HINCKLEY RAIL FREIGHT TERMINAL

Comments: Transport and Access

CPRE Leicestershire

Oct 2023

Figure 3-8: VCR 2015 base year, morning peak period - Leicester

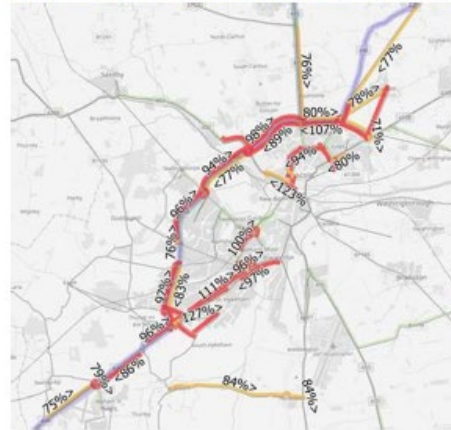
4.13 Figure 3.8 of that report shows that capacity already exceeds 85% (a proxy for congestion) on several sections around Leicester in the a.m. peak, most notably Hobby Horse Island a well-known pinch point to the North of the City.

Figure 5-7: Key Desirable and Undesirable HGV Routes

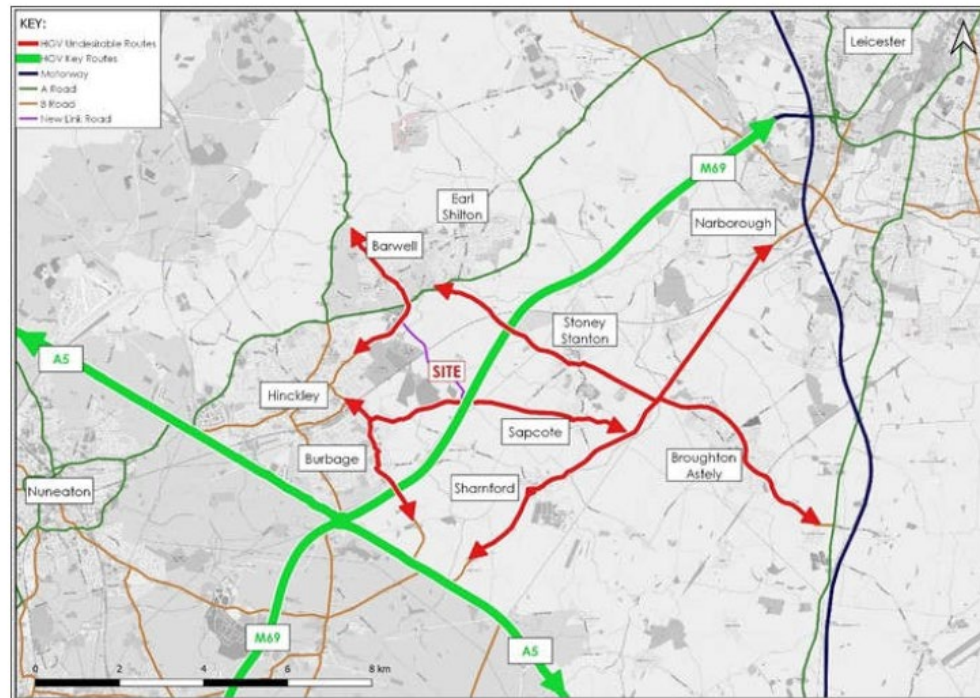
5.36 Figure 5.7 identifies routes which it considers are undesirable for HGVs. Those include routes which even according to the modelling by Tritax will see HGV increases with the development in place according to Table 8.19 of the EA, such as the B4669 through Sapcote.

5.37 Clearly, the impact on these other roads will be much more serious at times when the M69 is not available and development traffic is diverted. This needs to be fully considered.
